Analysis Branch
Division of Systems Safety
Office of Nuclear Reactor Regulation

SAFETY EVALUATION REPORT
ON
ECCS EVALUATION MODEL
FOR
WESTINGHOUSE TWO-LOOP PLANTS

November 1977

SAFETY EVALUATION SUPPORTING CONTINUED SAFE OPERATION
OF WESTINGHOUSE DESIGNED TWO LOOP PLANTS.....

Figure 12

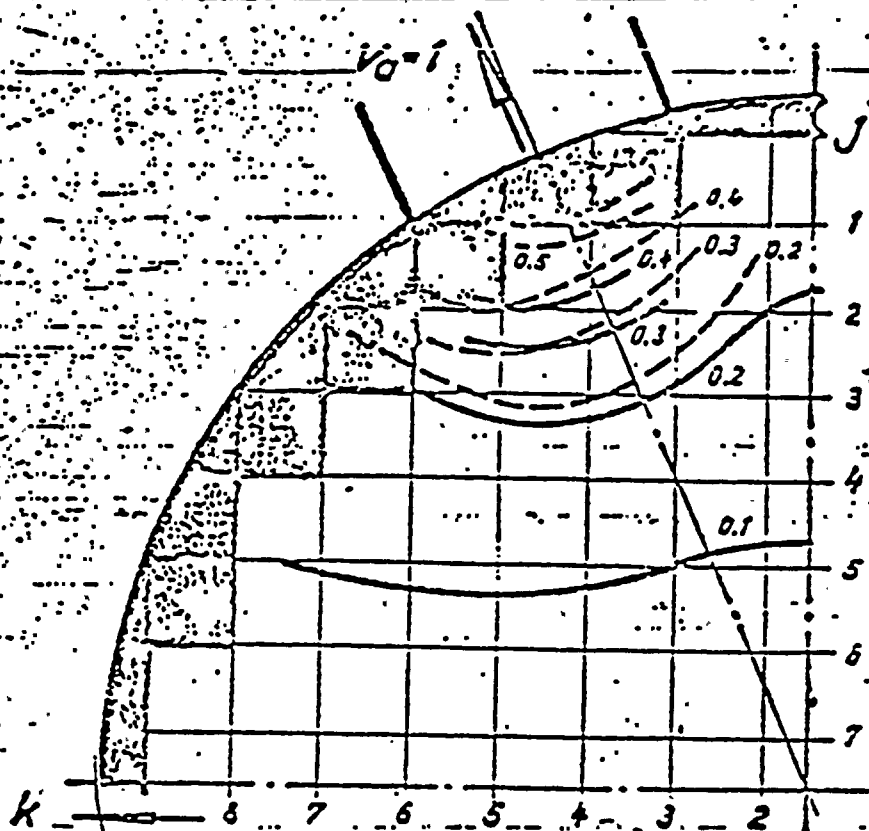
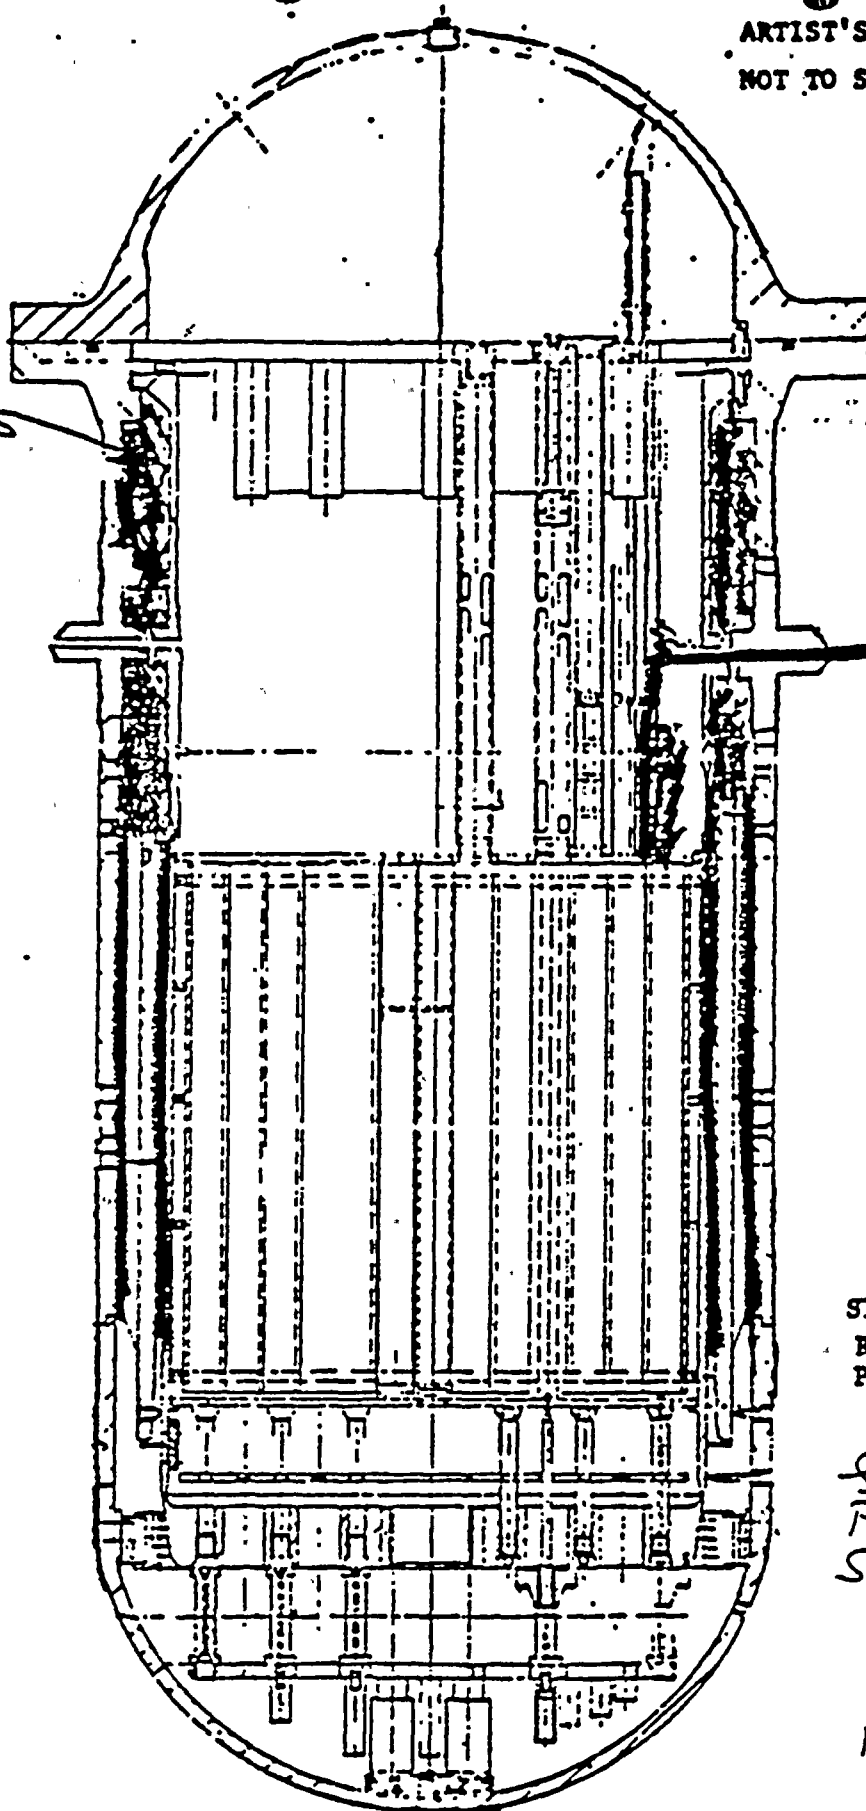
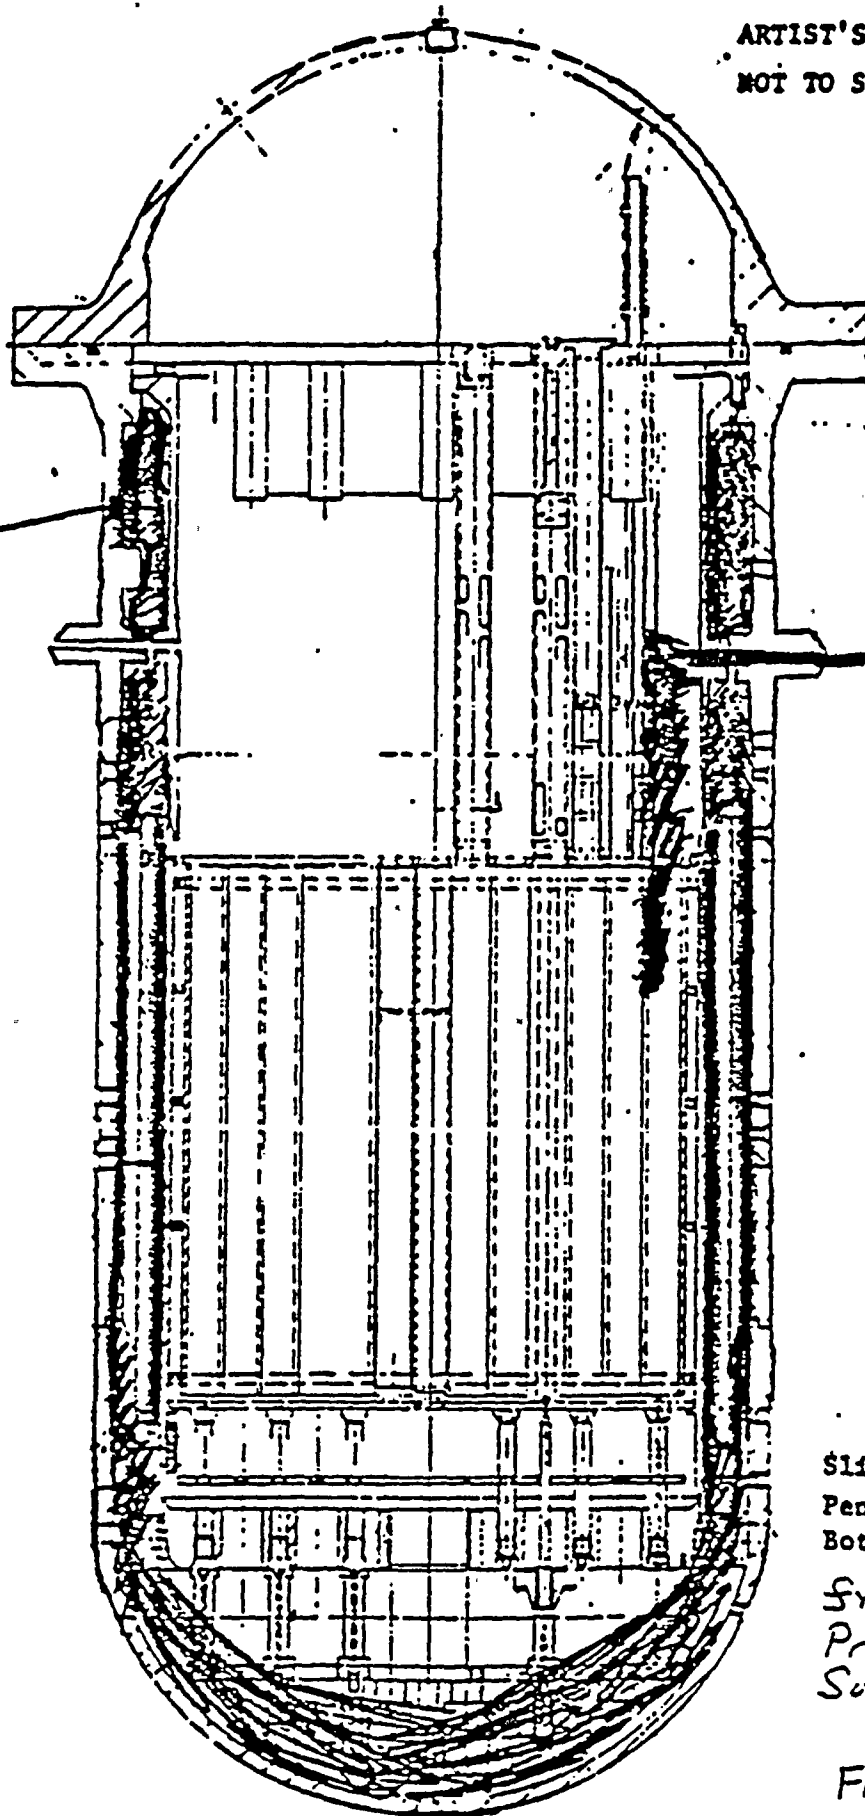
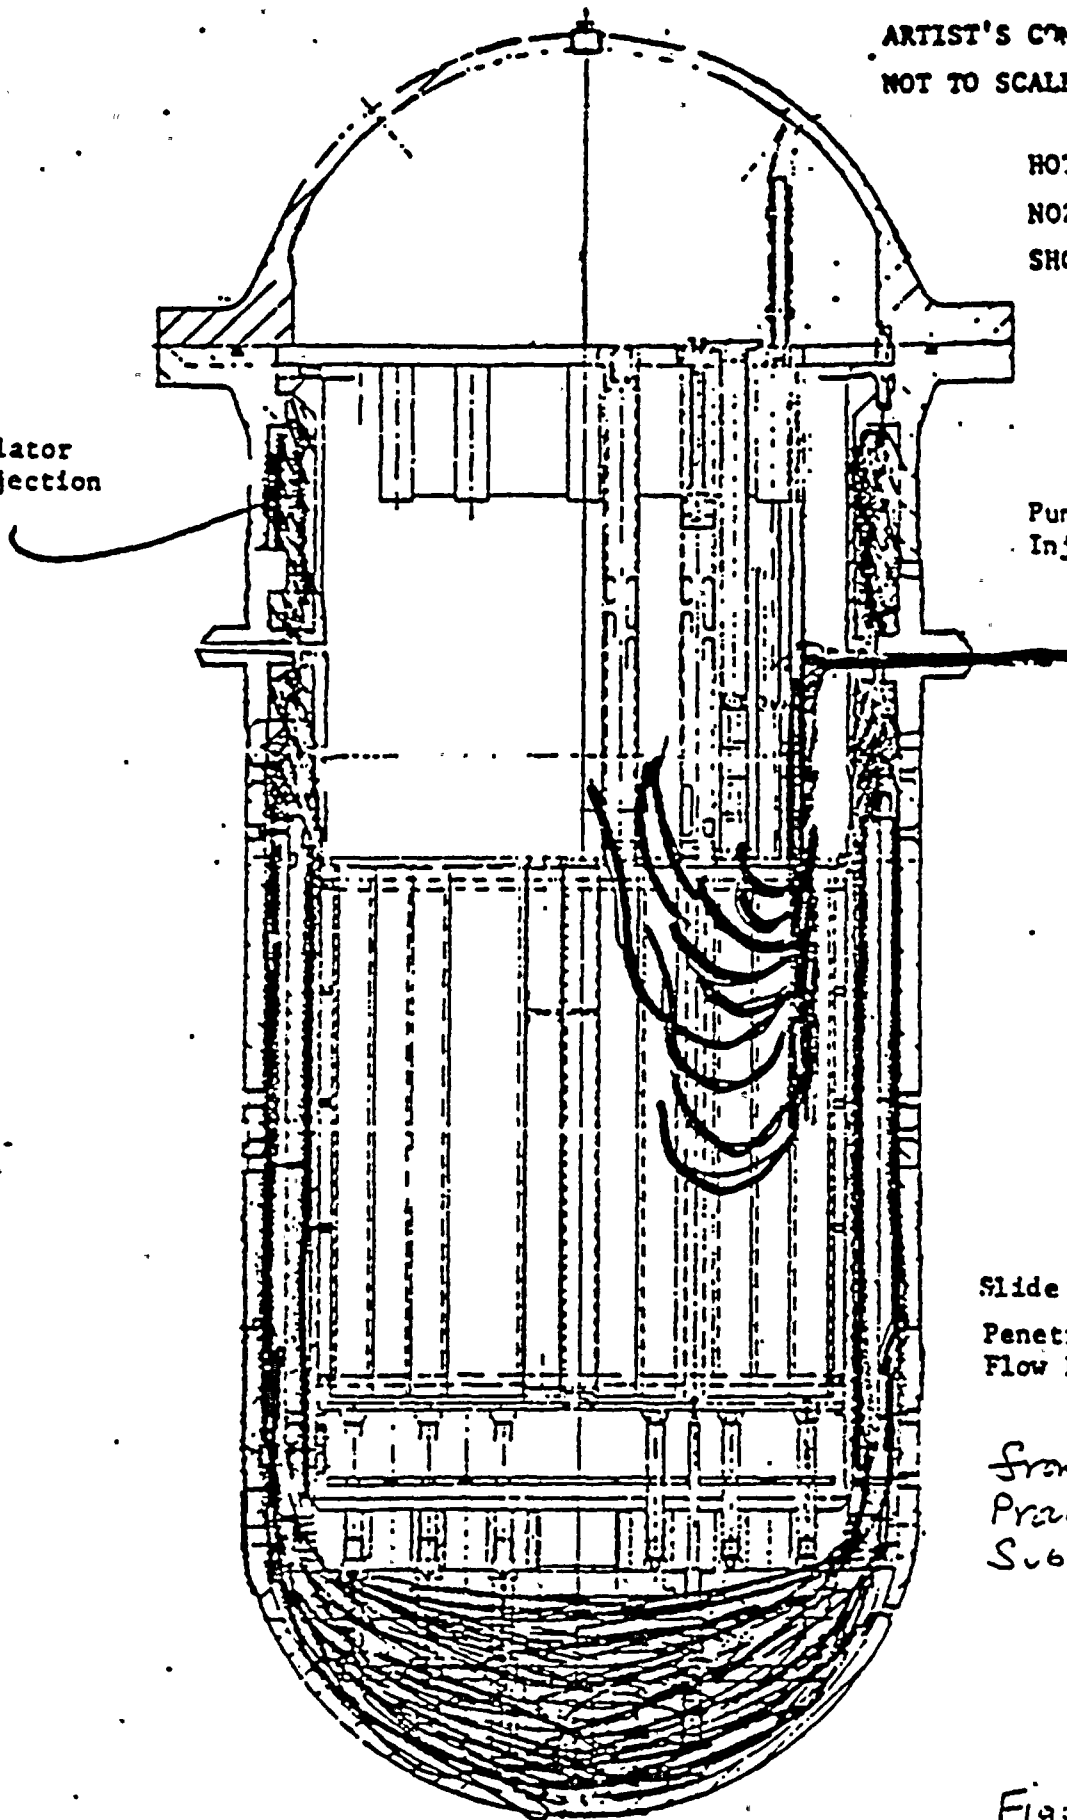
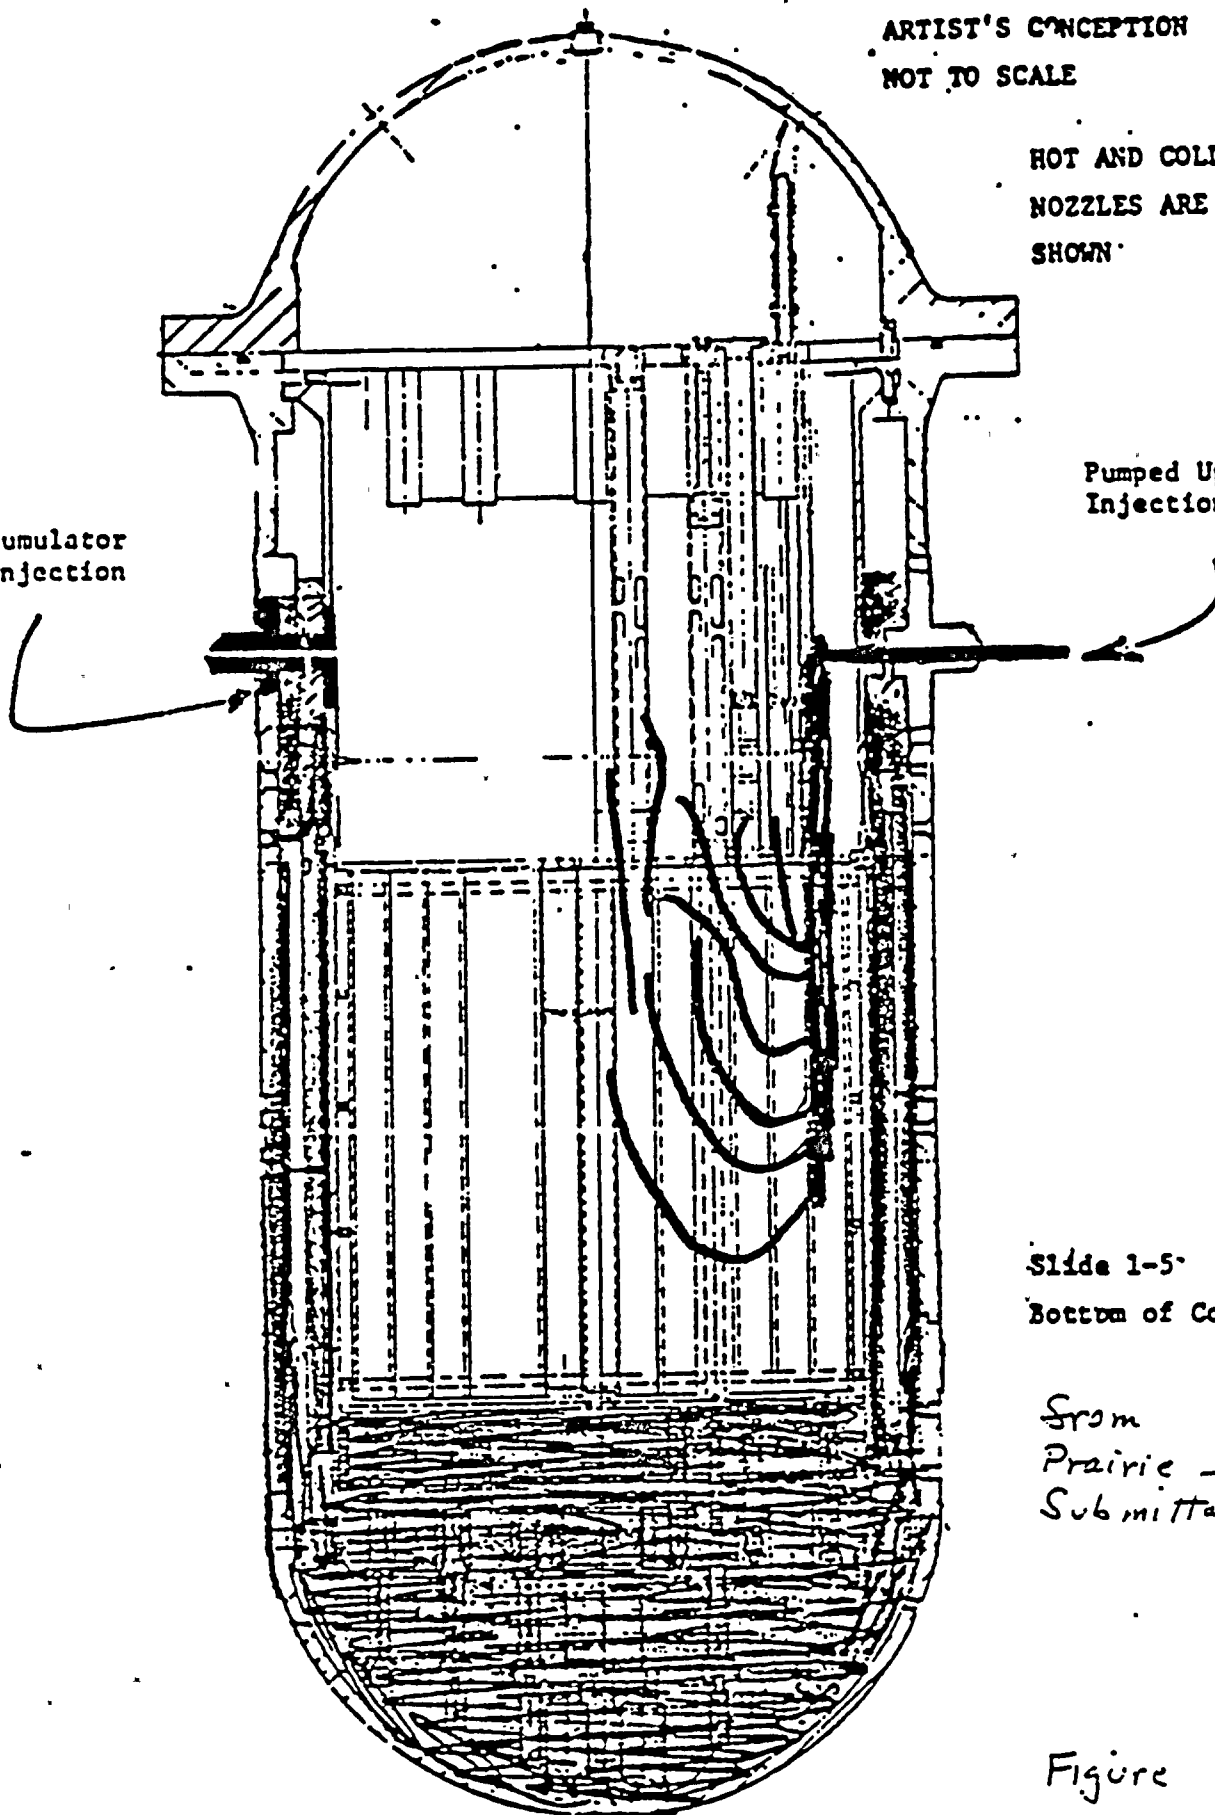
The key element in viewing the effects of upper plenum injection is the upper plenum injection flow distribution. The flow distribution is the controlling factor relative to steam generation, steam condensation and upper plenum injection water entrainment. The two-loop plant designer (Westinghouse) and the plant licensees description of the upper plenum injection flow distribution during blowdown, refill and reflood is shown in Figures 12 through 18.

Our review of the available information on upper plenum flow distributions indicates that the view of upper plenum injection as a highly localized flow (as presented by Westinghouse and the two-loop plant licensees) is not correct and is non-conservative. We conclude that the data supports the concept of a widely dispersed droplet flow in the upper plenum. For this condition, an integral model which treats the interactions among the controlling phenomena (i.e., heat transfer and quench; steam generation; entrainment and flooding; reflood rate) is required to establish the important assumptions; to identify the proper sensitivities to parameter changes; and to assess the overall effect on peak clad temperature. For these reasons we have constructed a simple, quasi-static model to study the bounding effects of upper plenum injection, and the sensitivity to various assumptions. In this model the reflood rate is calculated by adjusting the current evaluation model calculation of reflood rate to account for the additional steam generation associated with UPI.
